**RE: Williamsburg Landing Nursing and Living Facility  
(Now Woodhaven at Williamsburg)  
Plan No. SP-50-96  
BMP ID Codes: CC 012 (BMP 2 Timber Crib)  
AES Project No. 8162**

Re: Williamsburg Landing (County Plan SP-50-96)  
Nursing & Assisted Living Facility  
Record Drawings and Construction Certification

Project: Williamsburg Landing Nursing & Living Facility (now Woodhaven at Williamsburg)  
Plan No.: SP-50-96  
BMP ID Codes: CC 011 (BMP 1 Dry Pond) & CC 012 (BMP 2 Timber Crib)

SITE AND UTILITY PLAN  
DRAWING NO. C001  
COMMISSION NO. SCALE: 1" = 40'  
DATE: 6/25/96

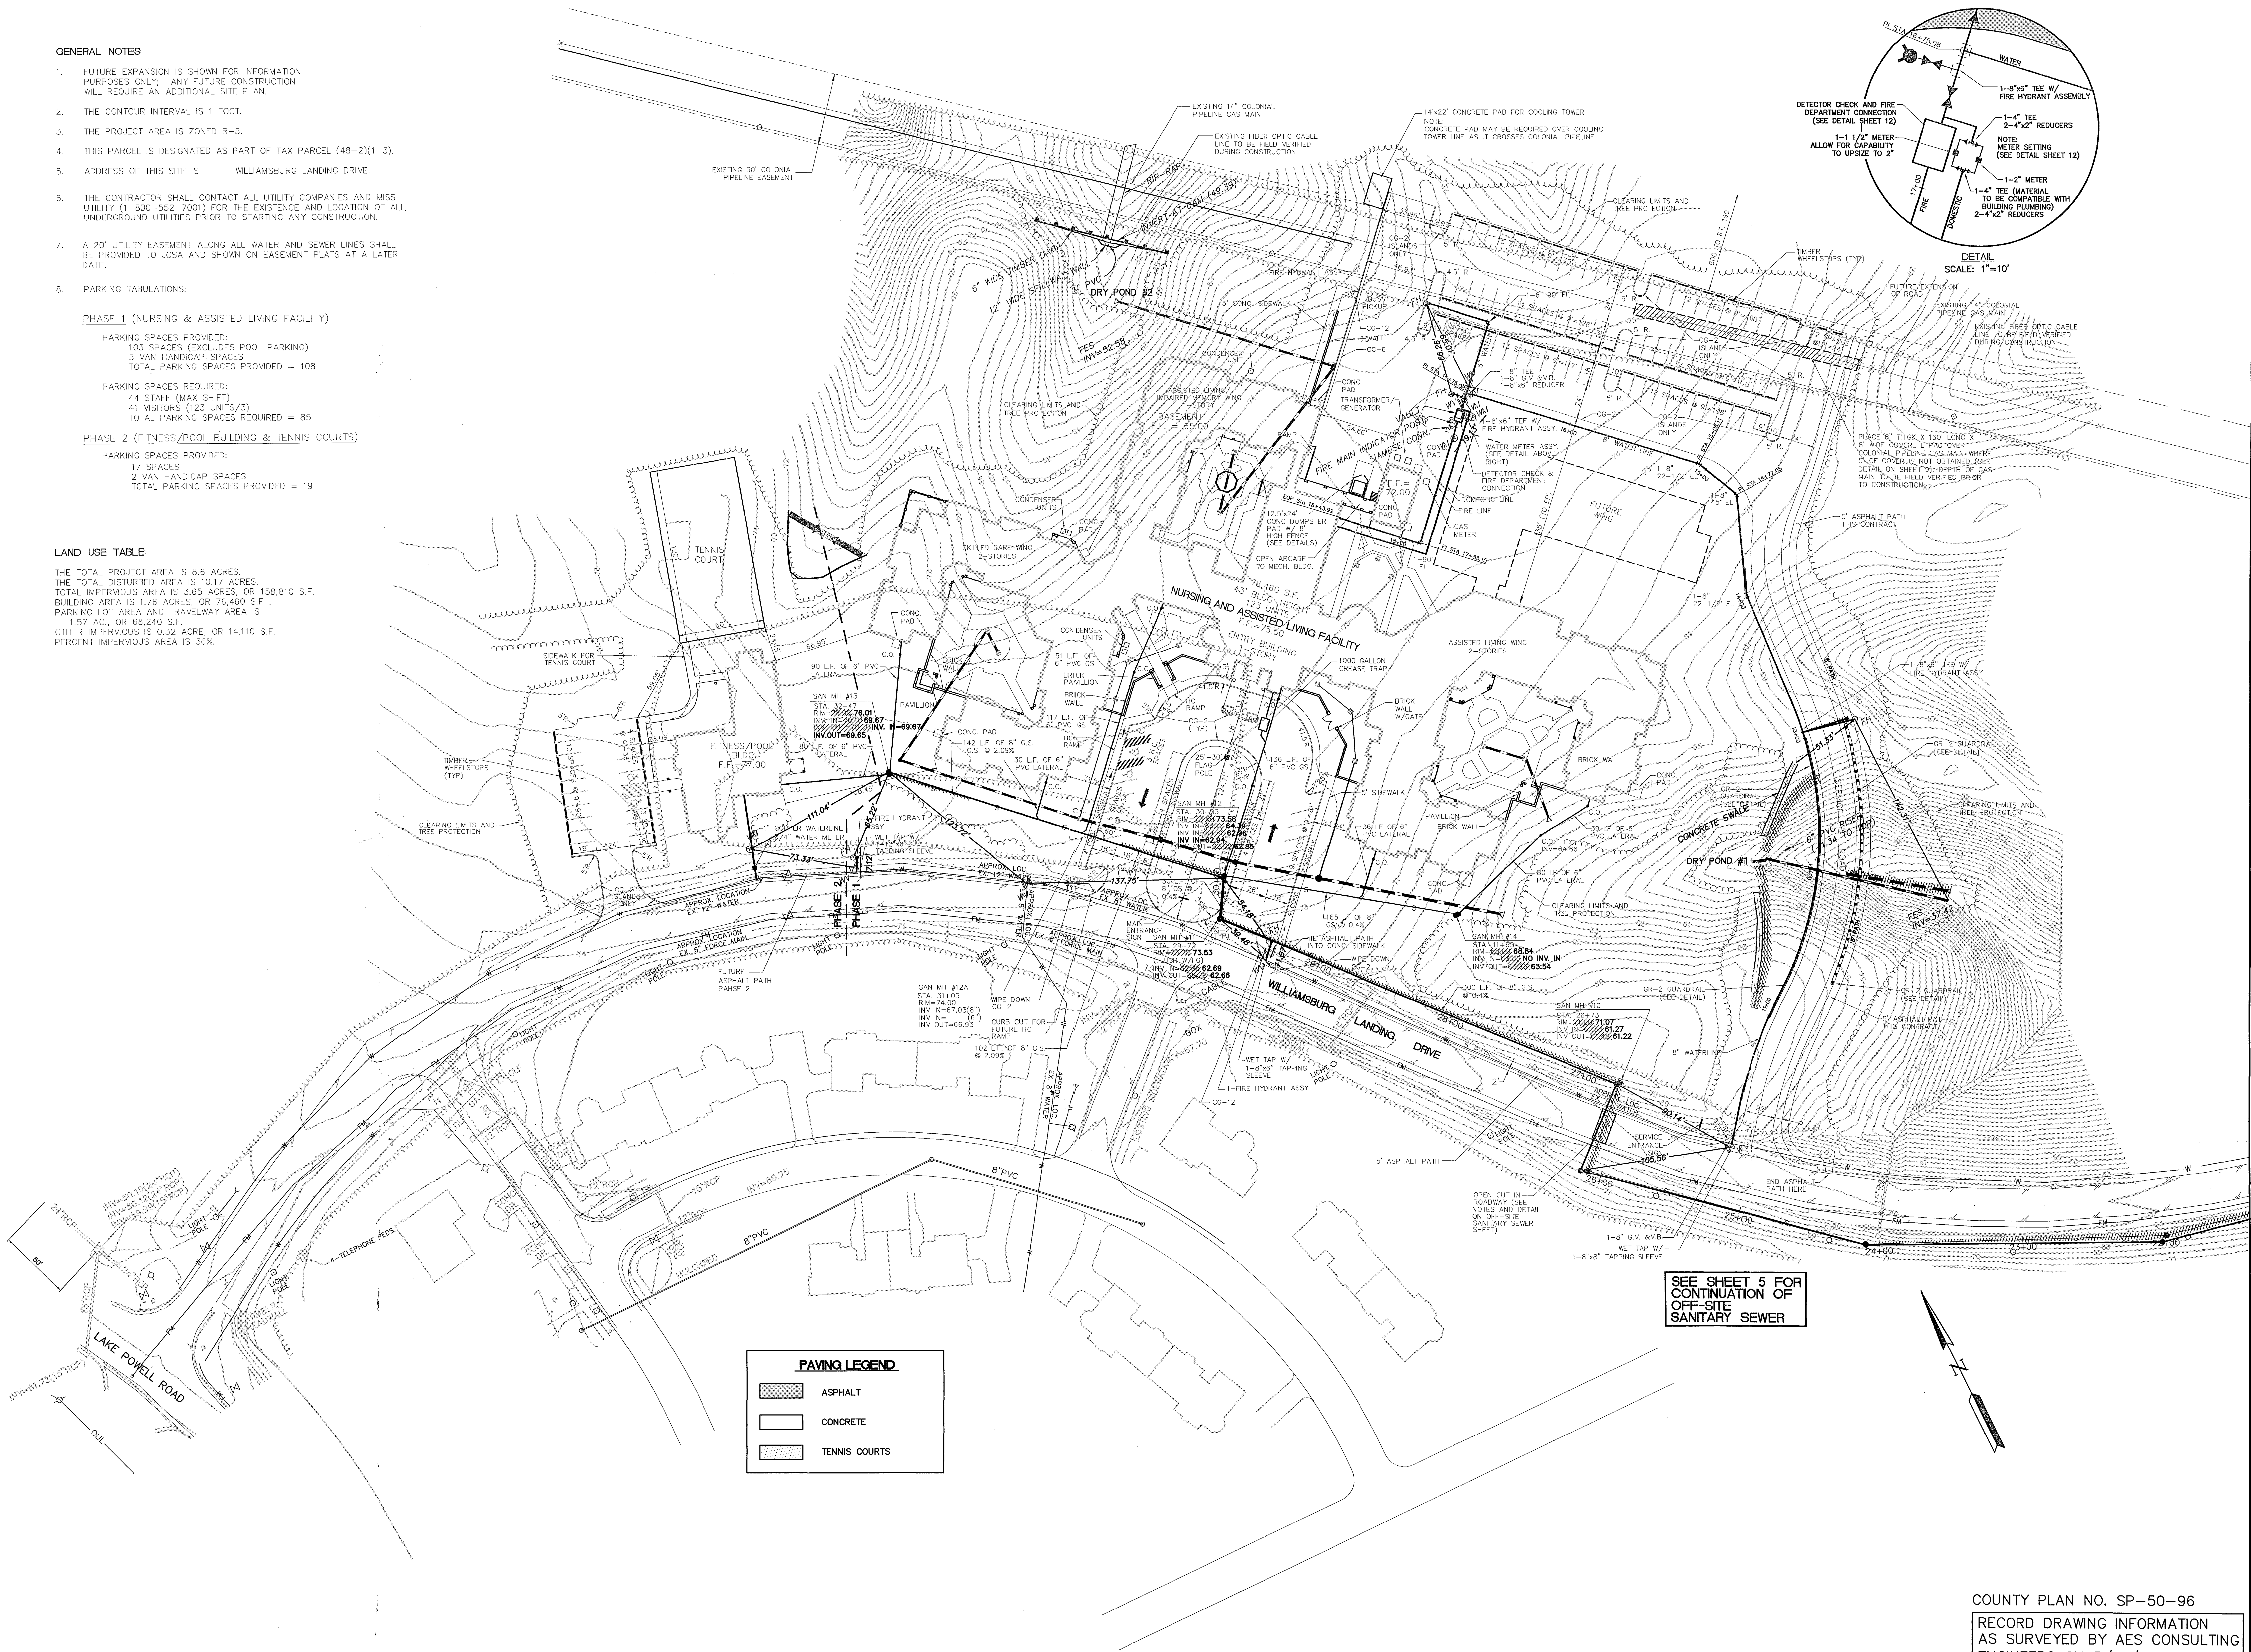
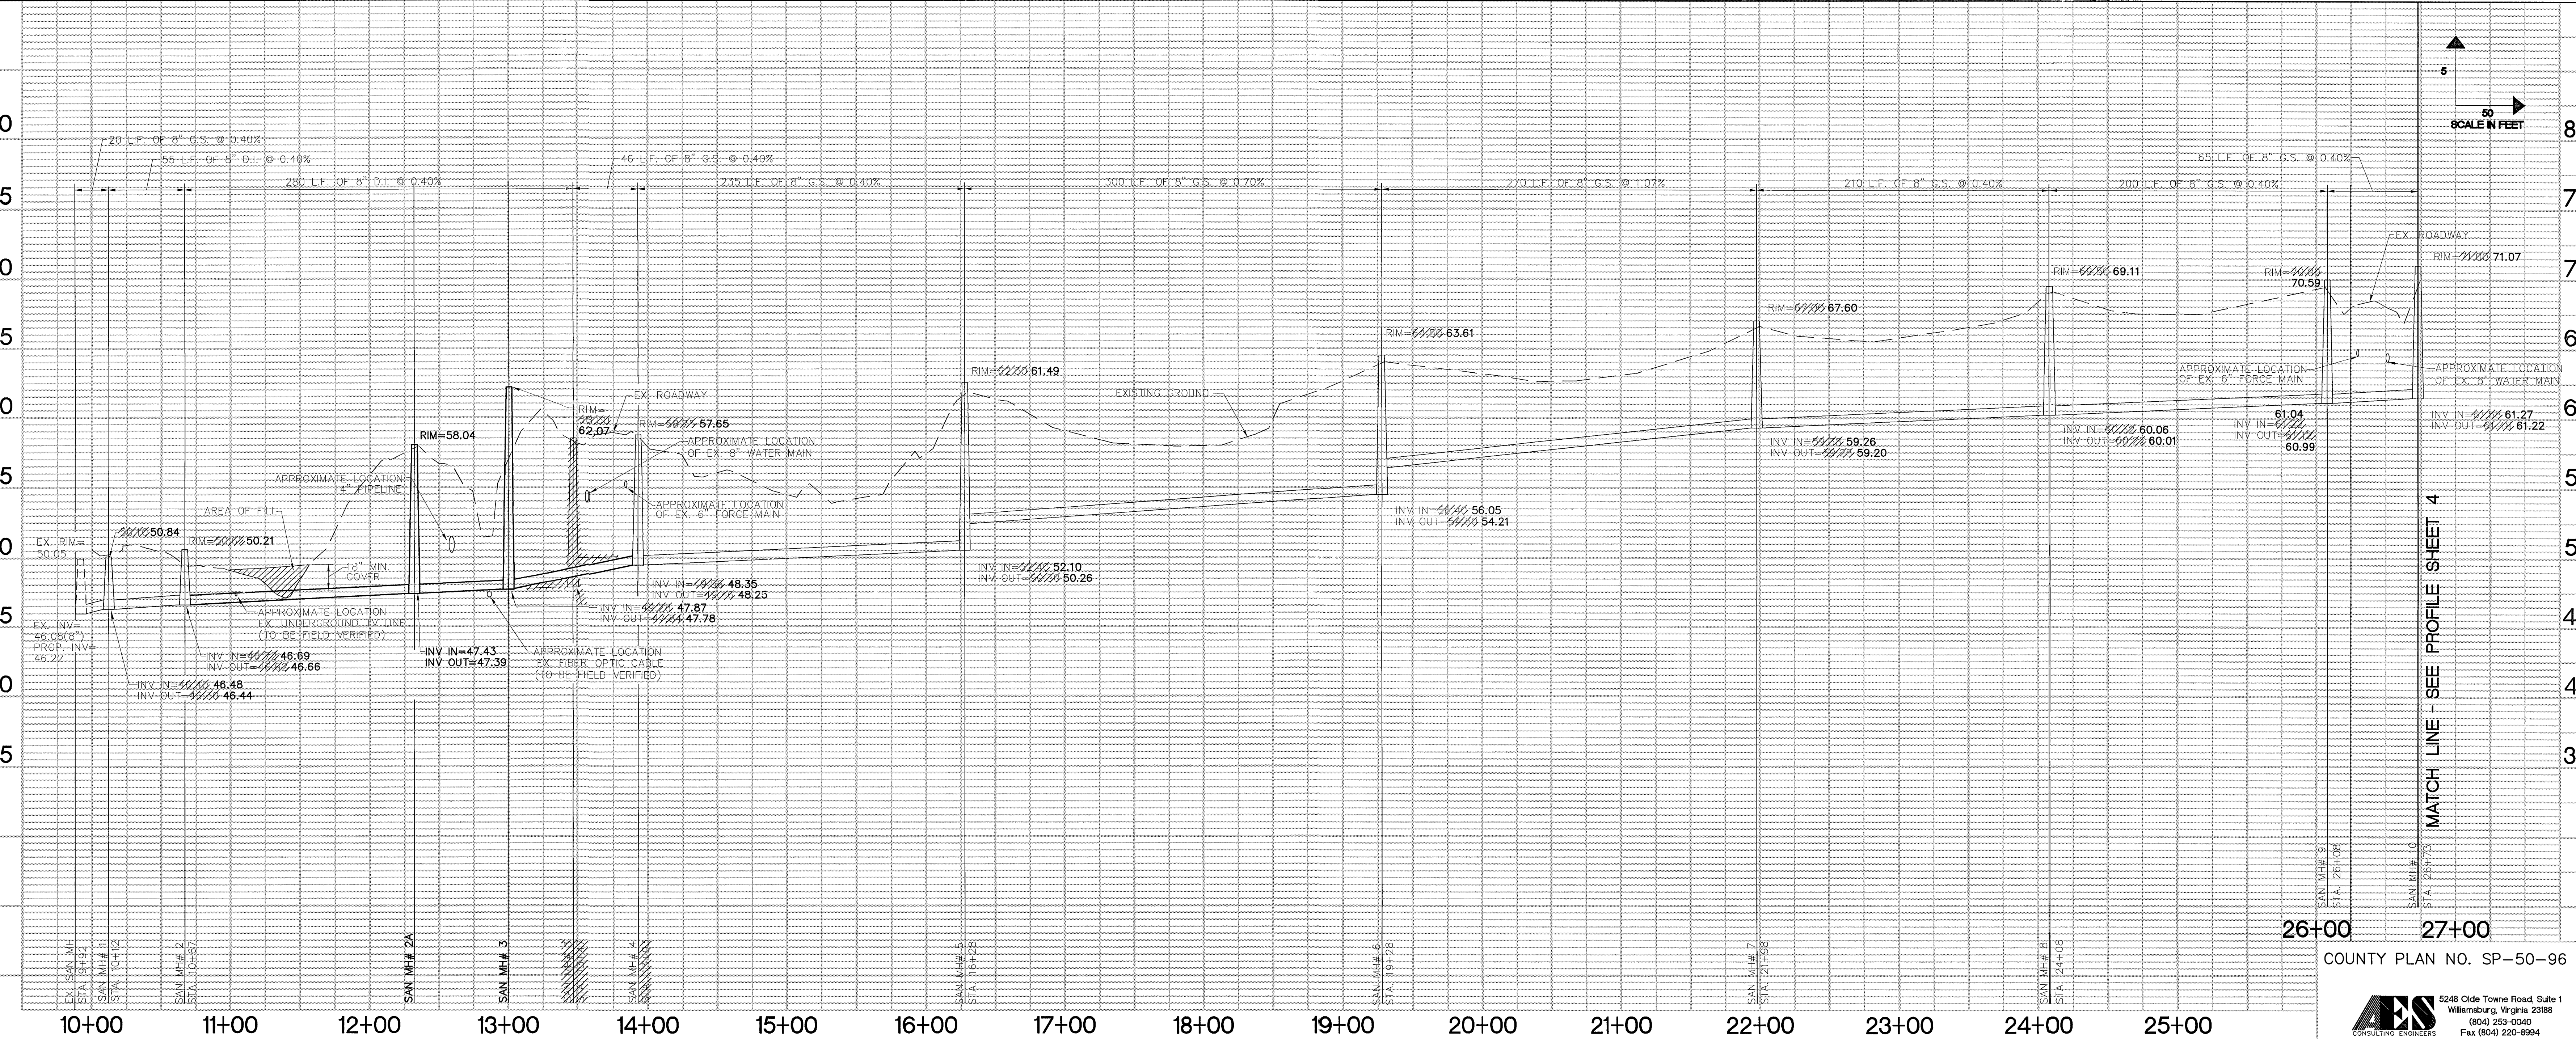
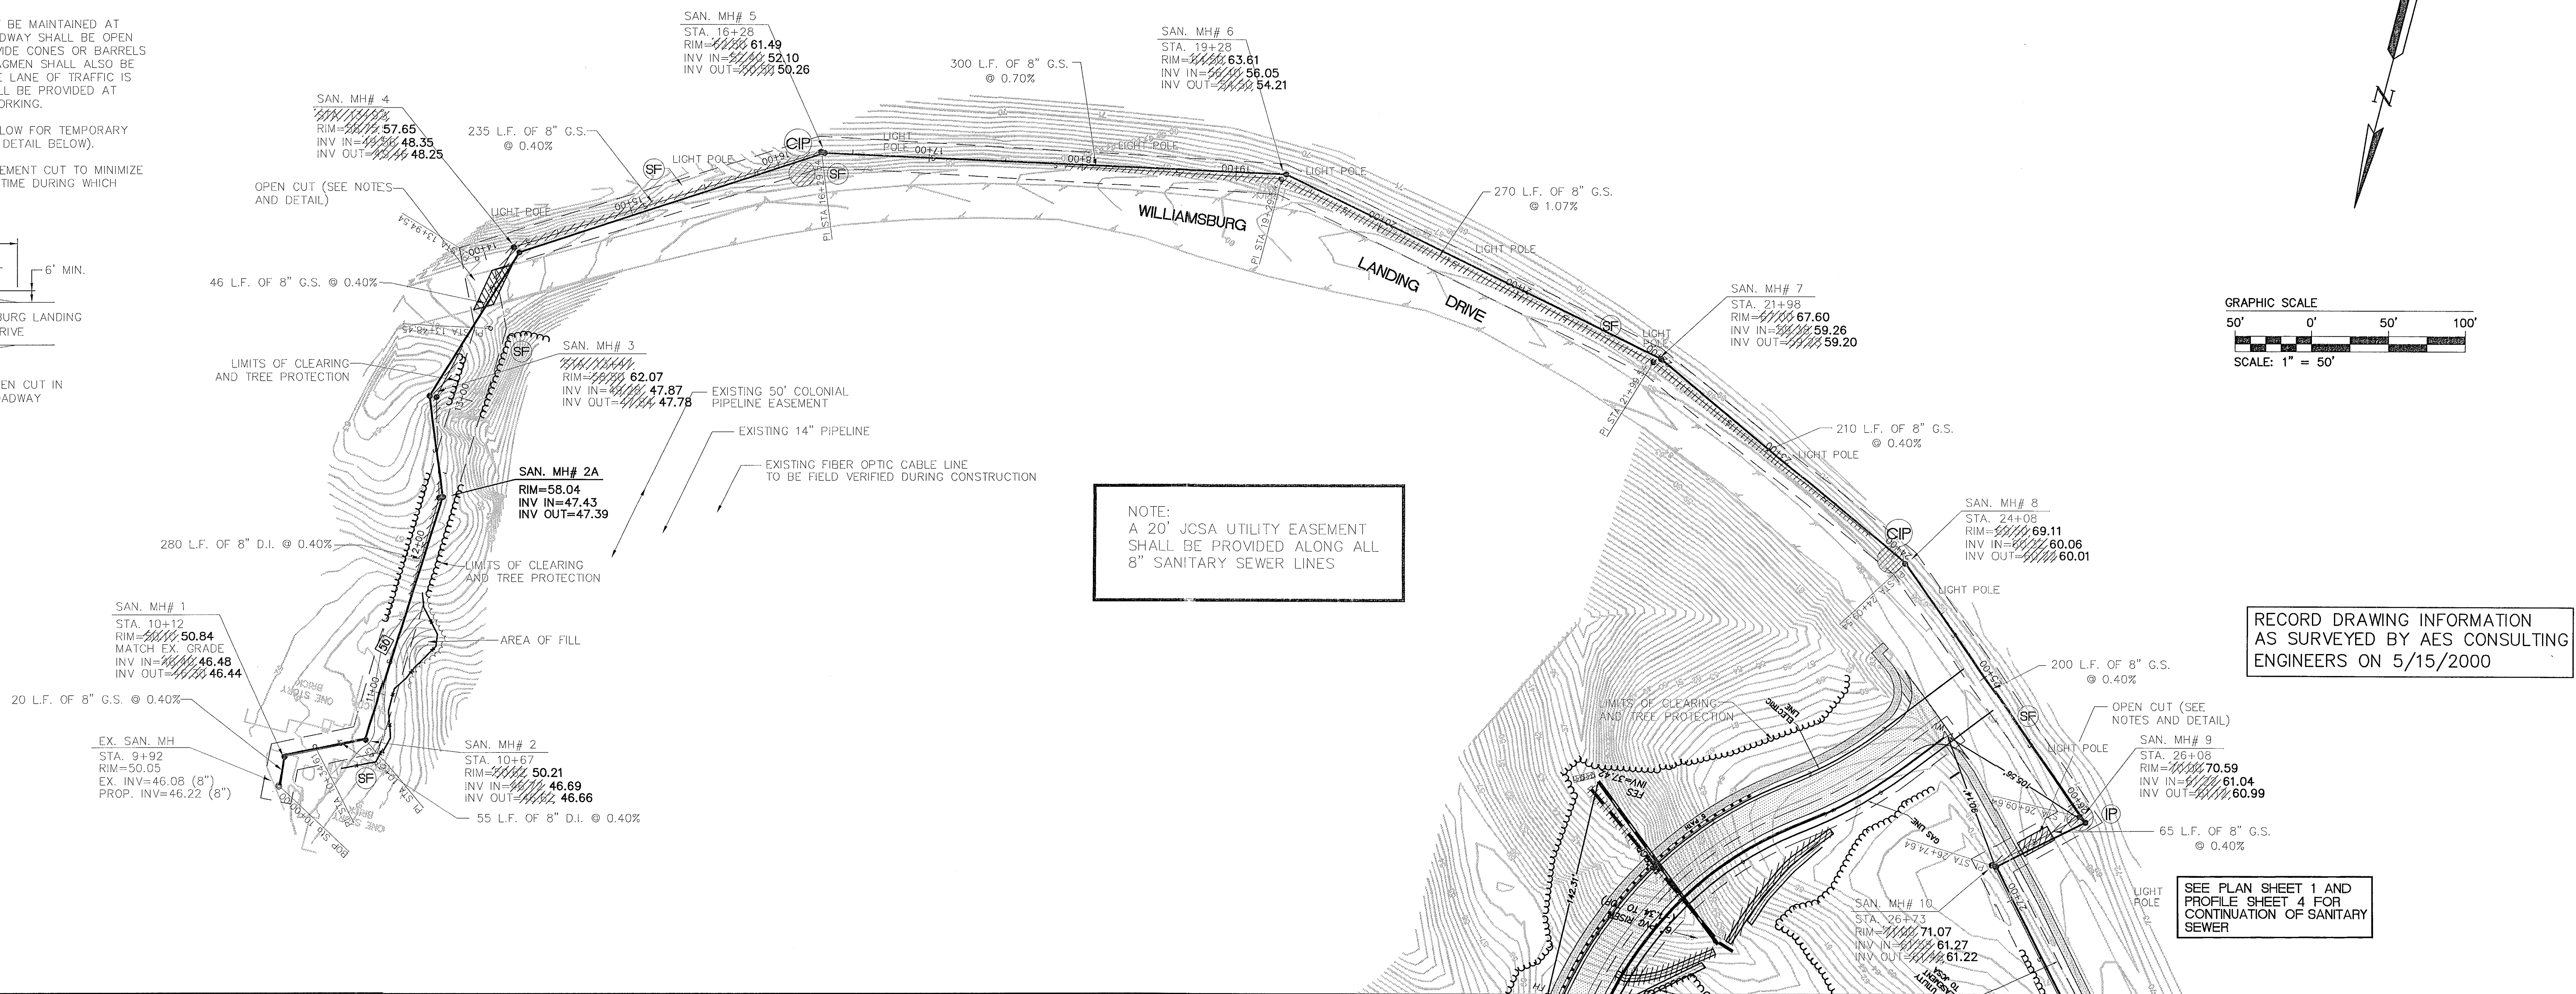
The Environmental Division has reviewed a record drawing set, consisting of Sheets C001, C005 and C010, as submitted to our office on June 7<sup>th</sup> for the above referenced project.

1. In accordance with Erosion and Sediment Control Note # 18 on Sheet 009 of the approved plan, construction certifications for the BMP's are required. None were provided.
2. Add approved County plan number (SP-50-96) at the bottom right hand corner of each sheet.
3. Consistently add labels Dry Pond # 1 and Dry Pond # 2, as appropriate, on record drawing plan views and details.
4. Dry Pond # 1. The as-built invert-in and invert-out elevation for the pond outlet barrel would result in an as-built pond barrel slope different from that of the approved design plan. Make this correction on the detail on record drawing Sheet C010 as necessary.
5. Date and sign the professional seal as provided on each of the record drawing sheets.
